Immingham Eastern Ro-Ro Terminal

Deadline 7 Appendices

**Associated Petroleum Terminals (Immingham) Limited and
Humber Oil Terminals Trustee Limited**

Planning Inspectorate Ref: TR030007

Figure 1 - Vessel Impact Protection Structures

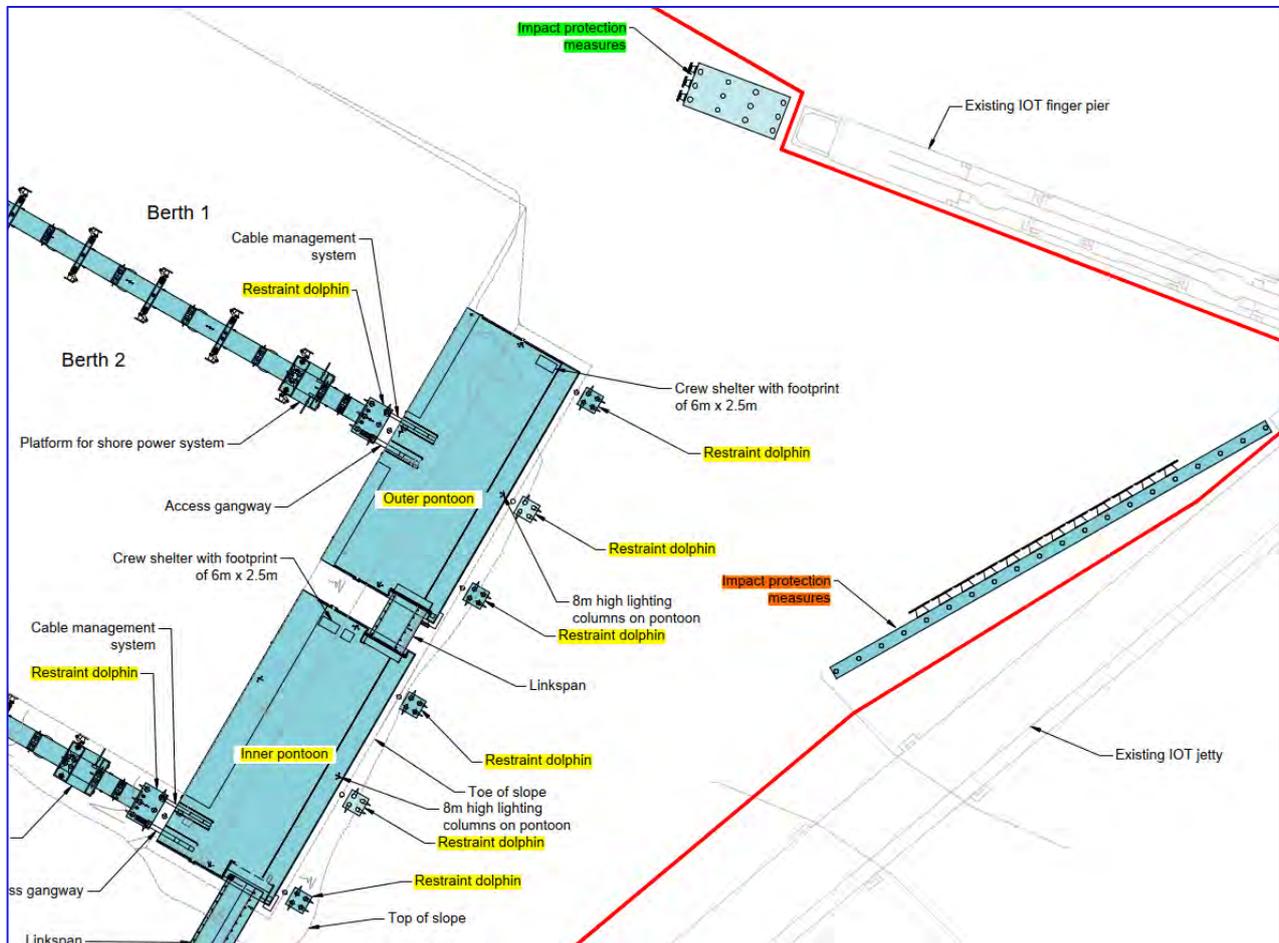
- 1.2.1 The future vessel impact velocity is 1.8knots, as opposed to 2.5knots for all other vessels. It's not clear how this has been determined and there is no justification within the document as to why the velocity is reduced for the future vessels.
- 1.2.2 There is no explanation of the possible modes of impact with the IOT structures and/or the protection structures. Likely impact scenarios should be set out so that the designer of the protection structures understands the possible angles of approach of the impacting vessel.
- 1.2.3 It is unclear how the 5m offset of the protection measures to the IOT structures has been assessed to be a safe offset distance. The document contains no assessment of whether 5m clearance is sufficient to prevent contact with the IOT

1.2.4 The design basis document doesn't clarify what impact the IERRT pontoons and associated restraint dolphins are designed for, and if these are designed to fail upon impact or will remain serviceable. There is a reference to a performance specification (doc ref: 4021009-JAC_ZZ-01-SP-C-00017) but this document has not been made available to the IOT team for review.
